Queens Quay Revitalization Environmental Assessment Public Forum #2 - Meeting Summary

Harbourfront Community Centre, December 8, 2008

Alternative 2: Centre Transit with Bike Lanes

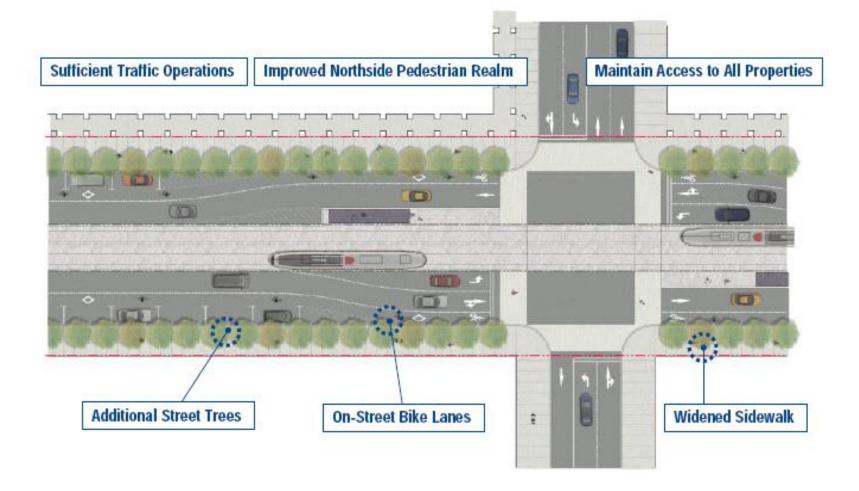
Participants identified a number of concerns with Alternative 2, as listed in the table below. Overall, many participants felt that Alternative 2 is not pedestrian, cyclist and youth friendly, has no connection to the Martin Goodman Trail, does not improve Queens Quay beyond the status quo, and will cause traffic delays. It was also suggested that cars and taxis will park in bike lanes, and noise pollution and air pollution will both increase.

What concerns do you have?			
 Not bike/pedestrian/kid friendly With one lane for cars each way, traffic will slow to a crawl Doesn't connect the Martin Goodman Trail Doesn't offer much aesthetic improvement to the street Lack of "destination" feel Lack of cyclist parking 	 Too similar to status quo Cars will park in bike lanes Not enough trees Noise and exhaust fumes from vehicular traffic Cars turning left have to cross in front of streetcars Cyclists getting knocked off bikes by people opening car doors

Participants discussed a couple of elements that they would like to improve or change for Alternative 2; a summary of ideas can be found in the table below. Overall, most participants would prefer to abandon Alternative 2 in favour of the Southside alternatives (Alternative 4 or 5). Participants suggested that if Alternative 2 was to be modified it would need separated bike lanes, physically separated from vehicles and pedestrians.

What changes or improvements would you suggest?			
 None - abandon this alternative Select Alternative 4 or 5 instead 	 Separate bike lanes from pedestrians and cars Remove parking from Southside and go with Alternative 3

Alternative 5: Southside Transit with Martin Goodman Trail with One-Way Traffic

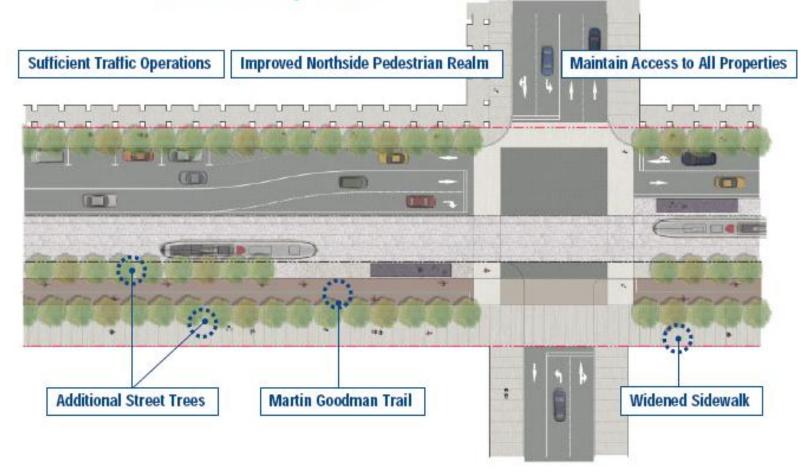
Participants expressed some concerns with Alternative 5, as listed in the table below. Overall, participants felt that Alternative 5 would create challenges for eastbound traffic, encourage speeding by cars, confuse tourists, restrict access to buildings on Southside, and cause problems with respect to access for emergency service vehicles.

What concerns do you have?			
	Cost to move transit line to the south Where will eastbound traffic go?	 Buses, taxis and private cars unloading waterfront visitors and blocking traffic 		
\triangleright	Pedestrians need to cross the Martin Goodman Trail to get to transit stops	 Not enough pubs, restaurants, cafés and useful shops along Queens Quay 		
\triangleright	One-way streets encourage speeding	Maintenance of trees and plants		
\triangleright	Tourists may be confused by the one-way street	Eastbound traffic on Lakeshore Boulevard will		
\triangleright	Access to buildings on Southside	increase		
	Capacity problems when road closures occur (e.g. Lakeshore Boulevard)	Access for emergency service vehicles

Participants discussed a number of elements that they would like to improve or change for Alternative 5; a summary of feedback can be found in the table below. Overall, participants would like to continue the design as far west along Queens Quay as possible, create a pathway from Union Station, eliminate parking on the south side, add more bike racks to the area, install cycling signals at eye level, create pick-up and drop-off bays for coach buses, lower speed limits, and plant more trees.

What changes or improvements would you suggest?			
Provide enclosed wind shelters at streetcar stops	Continue the design as far west as possible		
Plant lots of trees (especially coniferous trees)	Eliminate parking on south side		
 Create a pathway from Union Station (maybe enclosed) 	 Restrict traffic to local businesses and residents only 		
Lower speed limits	During morning rush hour have 2 lanes eastbound		
Water taxis to run the length of Queens Quay and	and one lane westbound		
stopping at major slip heads	During late afternoon rush hour, have 2 lanes		
Passenger unloading bays near main intersections	westbound and one lane eastbound		
for coach buses	More bike racks		
Coach buses should be kept off of Queens Quay in	Make improvements to the Ferry Terminal		
large parking lots	Put the cycling signaling at eyelevel		
Tourists should walk to Queens Quay or be shuttled by small shuttle buses circulating for free between	Add low shrubs next to the transit lane so as to soften the edge between the bike trail and
